RE: Addendum No. 1

Eagle Avenue Drainage Improvements - City of Palmer

SHEET TITLE TYPICAL SECTION DETAILS	
SHEET C1.01	
DRAWN BY TLC	CHECKED BY CJB
DATE AUG 2022	SCALE AS NOTED
JOB NUMBER 22-009

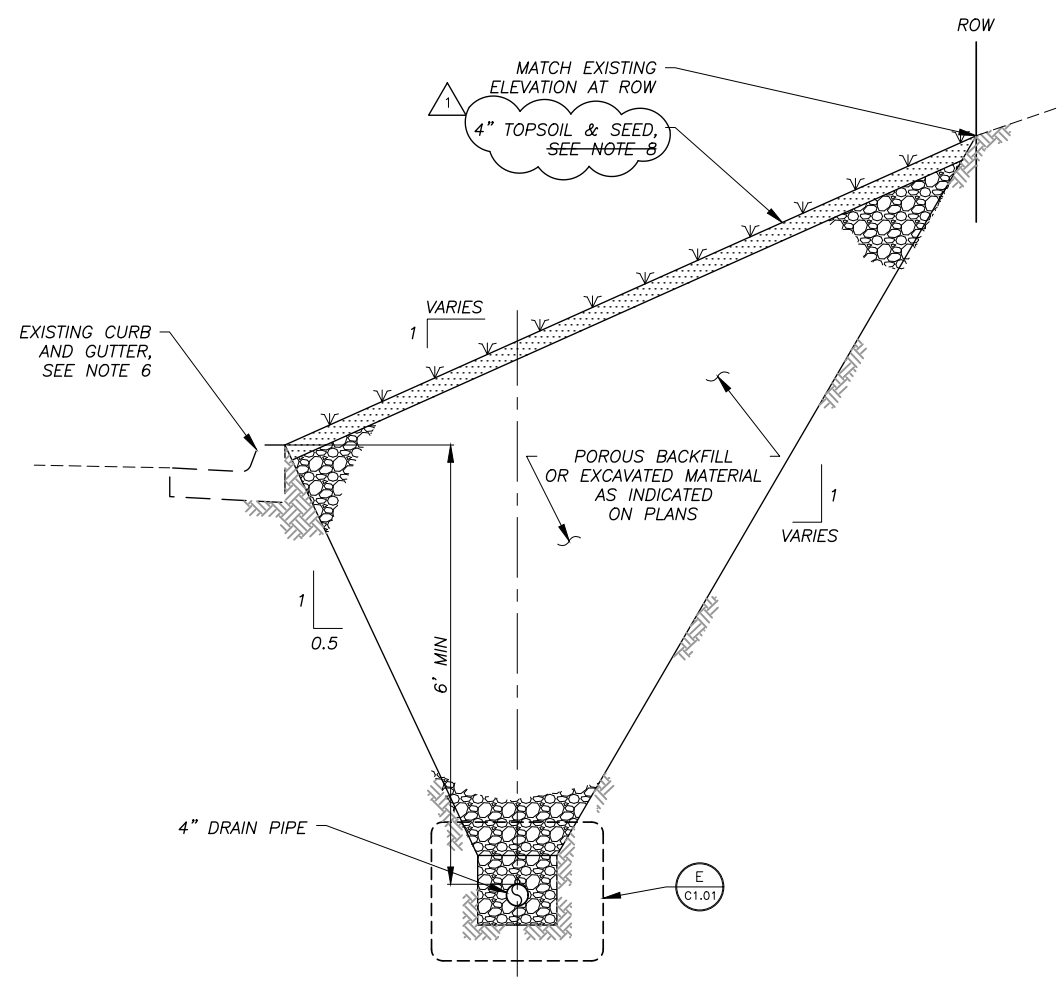
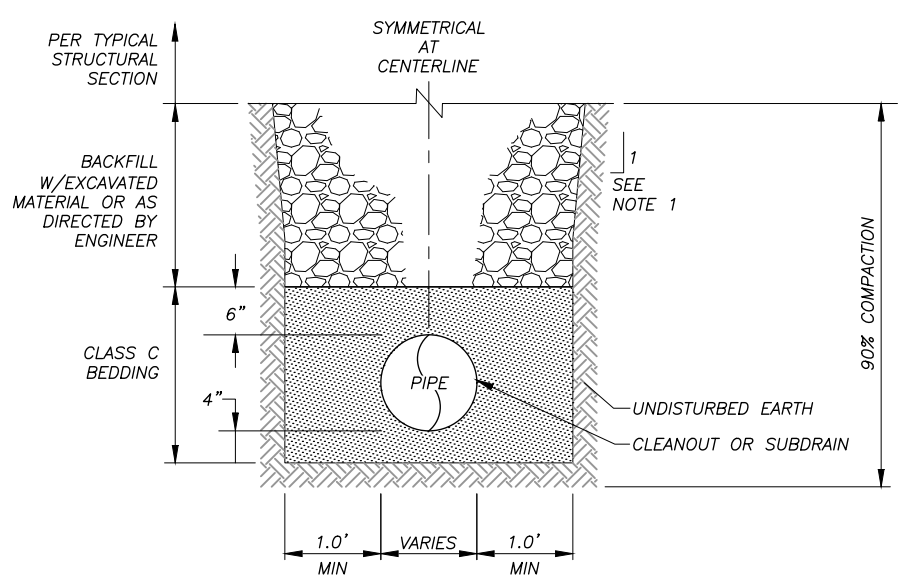
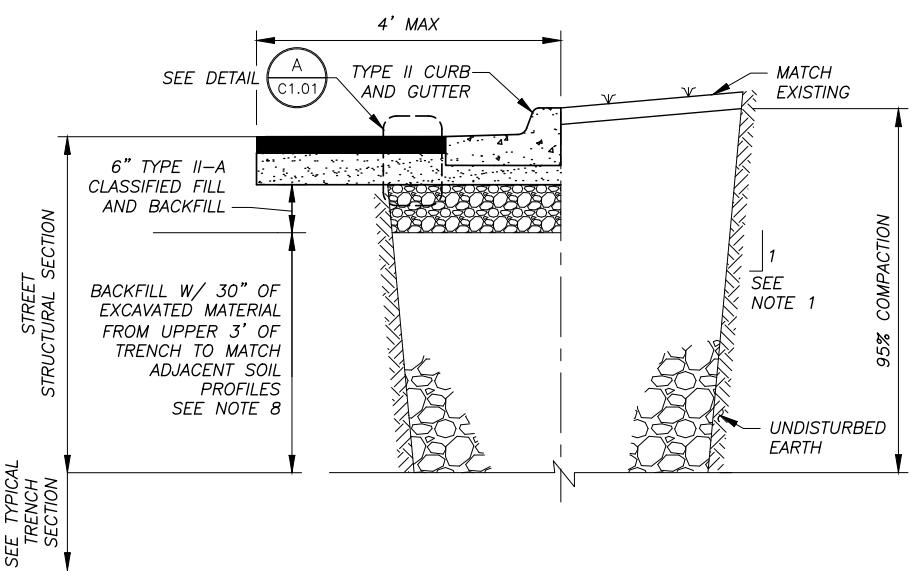
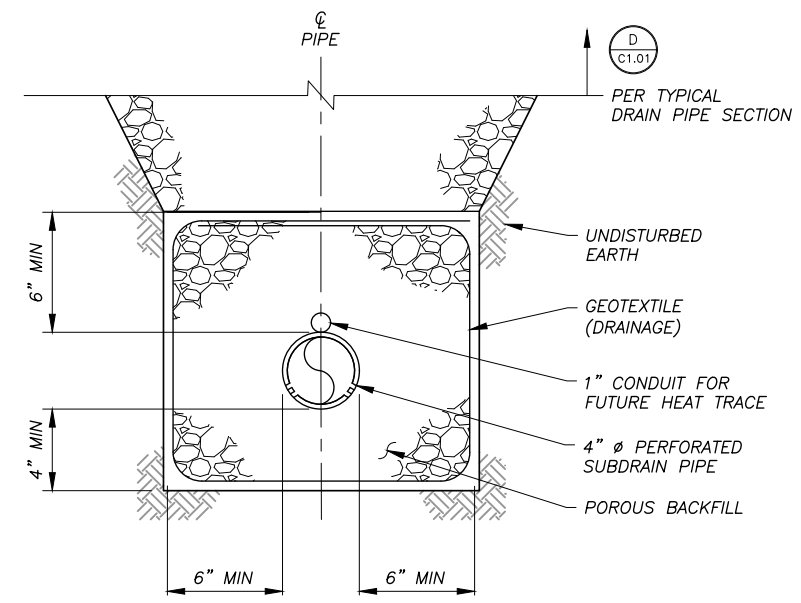
- A. Modification to Division XV PLANS
 - 1. Sheet C1.01. DELETE the entire sheet and SUBSTITUTE the attached Sheet C1.01, which removes a note requiring installation of soil stabilization matting prior to winter shutdown.
